UNITED STATES PATENT AND TRADEMARK OFFICE

APPLICATION NO.	F	ILING DATE	FIRST NAMED INVENTOR	ATTORNEY DOCKET NO.	CONFIRMATION NO.	
09/682,008		07/09/2001	David S. Leslie	11-SW-4904	1042	
23465	7590	06/20/2003				
JOHN S. B	EULICK	,	EXAMINER			
	OPOLITA	EASDALE, LLP AN SQUARE	ASSOUAD, PATRICK J			
ST LOUIS, MO 63102-2740				ART UNIT	PAPER NUMBER	
·				2857		
				DATE MAN ED OCIDOROS

DETAILED ACTION

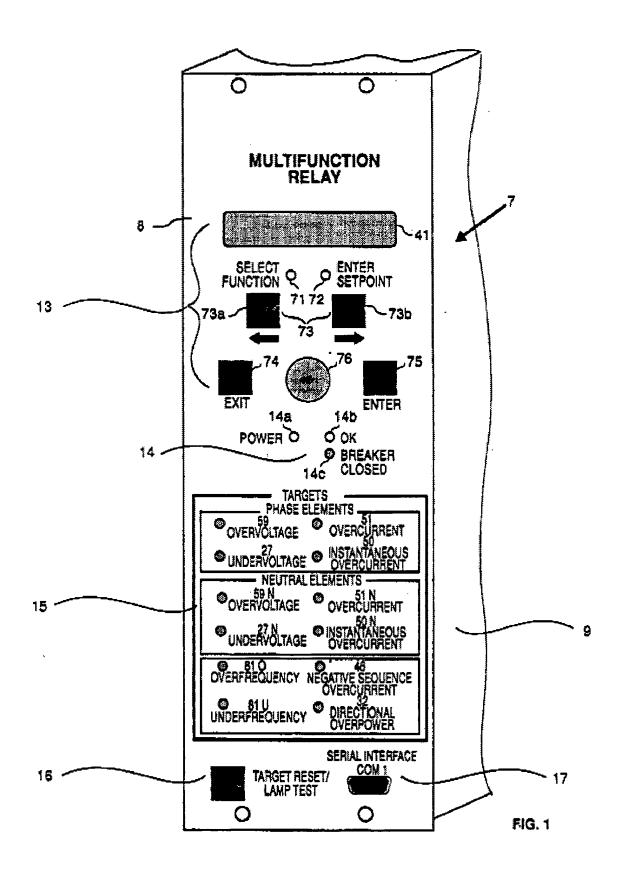
Note Figs. 1, 5 and 15 of Yalla et al.('011) are reproduced below.

- 6. The correspondence between the instant claimed invention and that of **Yalla et al.('011)** is as follows:
- a) "measuring at least one of a voltage, a current and a phase angle" is seen in at least Fig. 5 with the numerous voltage and current input signals 29;
- b) "displaying at least one of a relay contact status and the power values on a display" is seen in at least Fig. 1, see contact breaker status and various over- or under-voltage and current conditions, and also see the LCD element 41 of Fig. 5;
- c) a "plurality of electrical relays" is the plurality of relays connected to the input and output boards in Fig. 5;
 - d) a "display" is LCD 41 of Fig. 5;

e) a "microprocessor" and "memory" are the combination processor 43 & DSP36 and RAM 38 of Fig. 5; and finally,

f) a "plurality of printed circuit boards..." is the plurality of boards seen in at least Fig. 5.

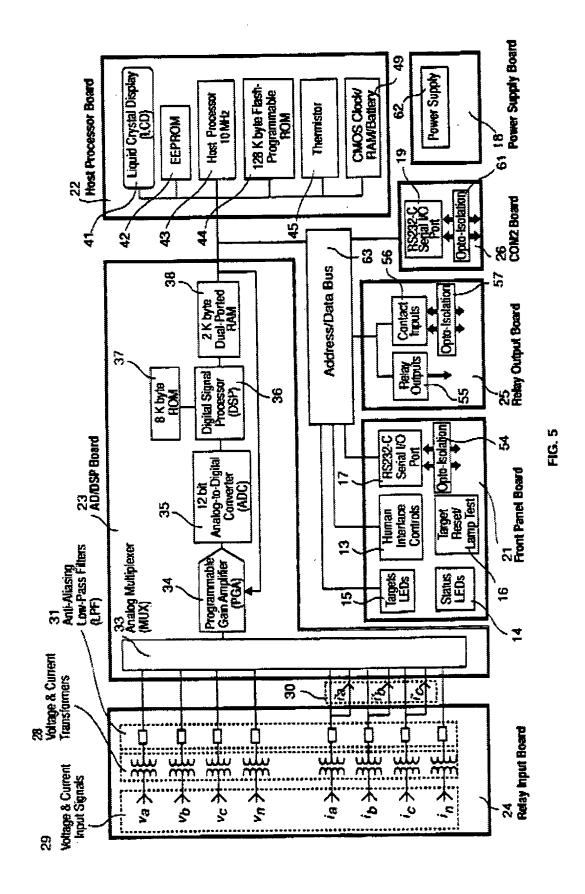
7. With respect to dependent claims 2, 16, 17, and 21, see at least the relay I/O boards of Fig. 5 and Fig. 15 of Yalla et al. which show numerous example relays and their related settings and related measurements.

With respect to dependent claims 7-8, and 18, see at least the Trip History of Fig. 15 or an example Trip time of occurence of Fig.16 of Yalla et al.

With respect to dependent claim 25, see at least the password of Fig. 15 of Yalla et al.
